## **MEMORANDUM**

**SUBJECT:** BZA Case 18708 – 4509 Foxhall Crescents Drive

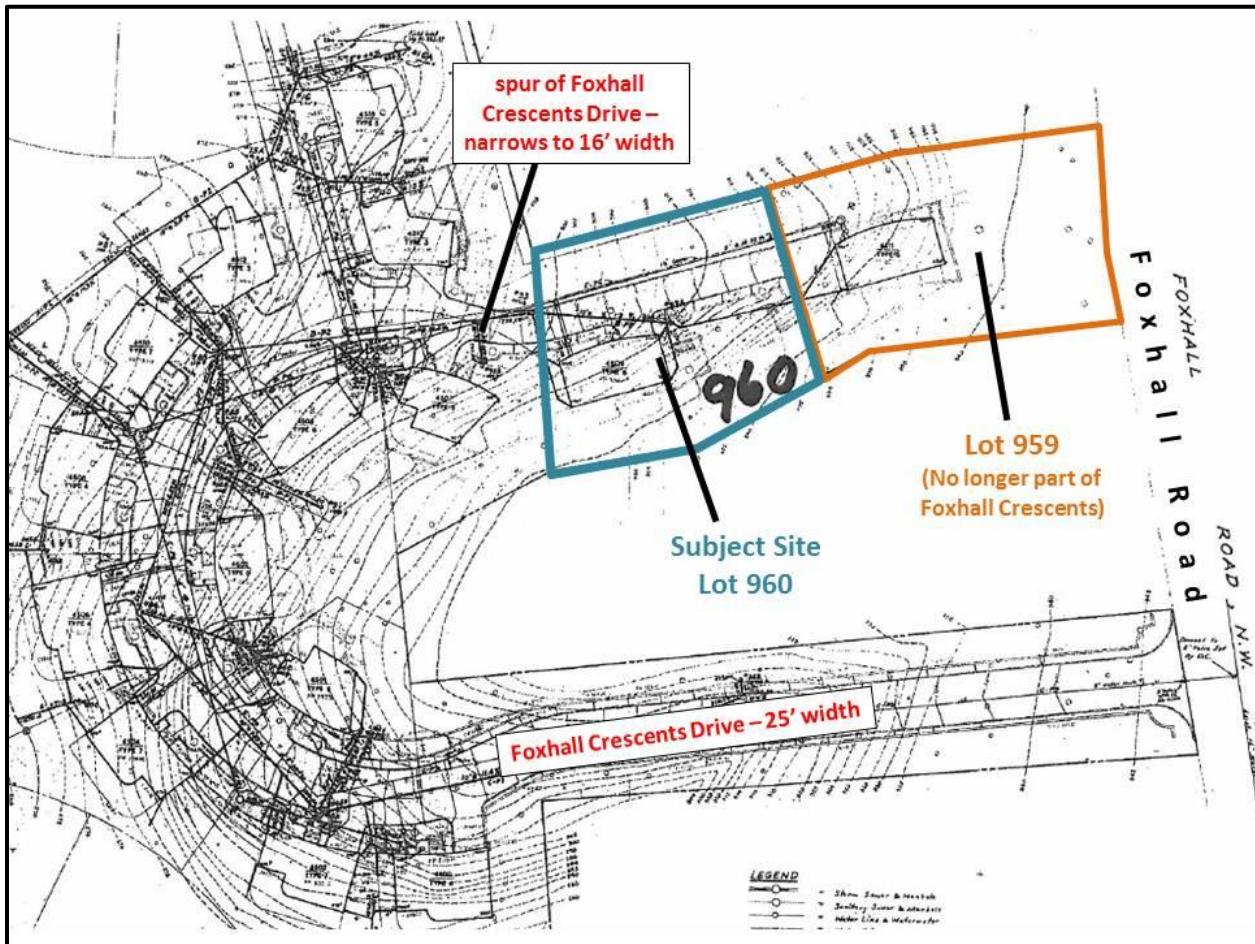
Foxhall Crescents Drive is an easement owned by each property owner. The easement continues across the entire east-west width of the subject property and would abut the front of the proposed house, a condition not unlike the other houses in Foxhall Crescents. Because of the location of the easement and a resulting zero-foot front yard, the applicant has requested relief from the front

yard requirement of § 2516.5(b). The applicant should also recalculate the lot area and lot occupancy as directed by this section.

Original 1979 Site Plan with 2014 OP Annotations

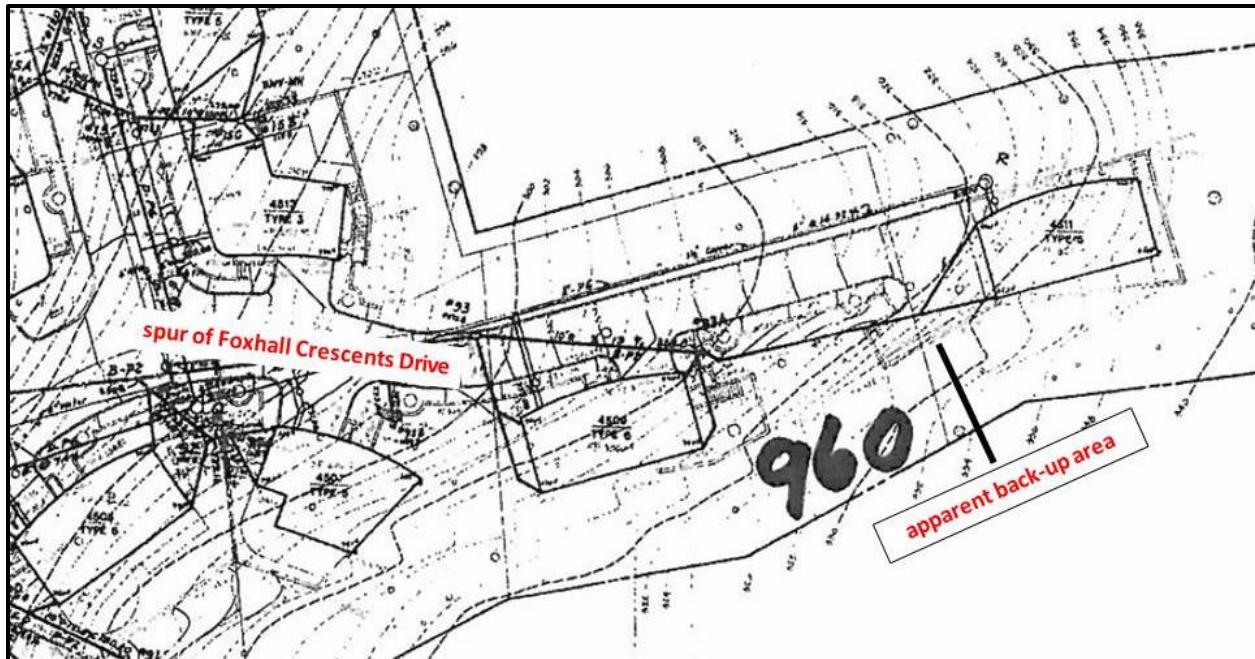
Pursuant to paragraph (d) the applicant has requested flexibility from paragraphs (b) and (c) in order to provide a 16 foot wide access easement and no turn around area. The main portion of Foxhall Crescents Drive has a curb-to-curb dimension of approximately 25 feet. On this spur, which serves just a few houses, the road narrows to about 16 feet curb-to-curb. This pattern seems consistent with other later phases of Foxhall Crescents which were approved under Section 2516 and granted relief from right-of-way width requirements. Those phases were also granted relief from the turn-around provision. The original layout of this portion of the street was also designed with no turn-around. The original site plan does show an extension of this spur, but given the odd angle of its alignment it is unclear what purpose it served. Based on the orientation the most likely scenario is that it was intended for vehicles backing out of a garage in the house on Lot 959. That lot is no longer part of Foxhall Crescents. Please refer to the site plans below.

OP discussed the application with the District Department of Transportation (DDOT), who had no concerns about traffic flow or parking given that what is proposed is only a single residence. OP also notes that each house has a two-car garage, including the house proposed for construction, so there should be adequate off-street parking in almost all circumstances. OP requested comments from the Fire and Emergency Medical Services Department (FEMS) who stated in an email that “After reviewing this documentation [the application materials], DCFEMS Office of the Fire Marshal has no objections. I can’t recognize any potential fire department access issues.” MPD responded to an OP request for comments with the following statement: “Beyond typical issues surrounding construction sites (e.g., traffic, work-site safety), the Metropolitan Police Department (MPD) has no unusual public safety concerns relating to this project. Thank you for providing the Department with the opportunity to comment.” Based on the information available to date, OP has no objection to the 16’ roadway width and lack of turn-around. The roadway would function more like a private driveway rather than a street, and

because it would be built in conformance with the original plan for Foxhall Crescents it would not have an adverse effect on the character of the neighborhood. OP therefore recommends approval of the requested flexibility pursuant to § 2516.6(d).
